## **Access Compliance Report Public Rights-of-Way** (Curb Ramps)

Intersection ID: 31877 Main Street: WILLIAMS GLENN RD **Cross Street: SANDY PORTER RD** Location: NW ADA ID: 210EC4FA0D53 Ramp Type: PerpDiag Initial Pass/Fail: Fail **Overall Compliance: No** Severity Score: 33.75

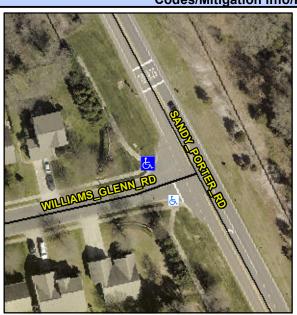
Possible Solutions: Remove & Replace Curb Ramp With Two New Directional Ramps or Equivalent. Surveyor Notes: N/A PROW/ADA: Not Found, R304.5.1, R304.2.2, R304.5.3

Field Measurements/Component Compliance					
Compliance Description		Data	Comp	liance Description	Data
N/A	Ramp Length (in)	93.0	No	Ramp Slope (%)	9.9
No	Ramp Width (in)	47.0	No	Ramp XSlope (%)	5.1
N/A	Flare Type LT	N/A	N/A	Flare Type RT	N/A
N/A	Flare Slope LT (%)	N/A	N/A	Flare Slope RT (%)	N/A
N/A	Flare Traversable LT?	N/A	N/A	Flare Traversable RT?	N/A
N/A	Landing Length (in)	N/A	N/A	DWS Provided?	N/A
N/A	Landing Width (in)	N/A	N/A	DWS Contrast?	N/A
N/A	Landing Slope (%)	N/A	N/A	DWS Length (in)	N/A
N/A	Landing X Slope (%)	N/A	N/A	DWS Full Width?	N/A
N/A	Landing Curb? (Y/N)	N/A	N/A	DWS Offset (in)	N/A
N/A	Shared Landing?	N/A			
N/A	Gutter Ponding?	N/A	N/A	Gutter Slope (%)	N/A
N/A	Gutter Lip Ht (in)	N/A	N/A	Gutter X Slope (%)	N/A
N/A	Painted X Walk1?	No	N/A	Painted X Walk2?	No
	X Walk 1 Direction	To SE		X Walk 2 Direction	To NE
N/A	X Walk 1 Width (in)	N/A	N/A	X Walk 2 Width (in)	N/A
	X Walk 1 Slope (%)	2.8		X Walk 2 Slope (%)	1.8

X Walk 1 X Slope (%)	2.7		X Walk 2 X Slope (%)	1.8
N/A	Ramp inside XWalk1?	N/A	N/A	Ramp inside XWalk2?	N/A
	Road Slope (%)	4.2	N/A	Clear Space?	N/A
	Road X Slope (%)	1.4	N/A	Clear Space to XWalk (in)	N/A
N/A	Any Obstructions?	N/A	N/A	Storm Grate/Utility Hazard?	N/A
	Obstruction Type			Storm Grate/Utility Type	
		N/A			N/A
			Yes	Surface Condition? (G/P)	Good
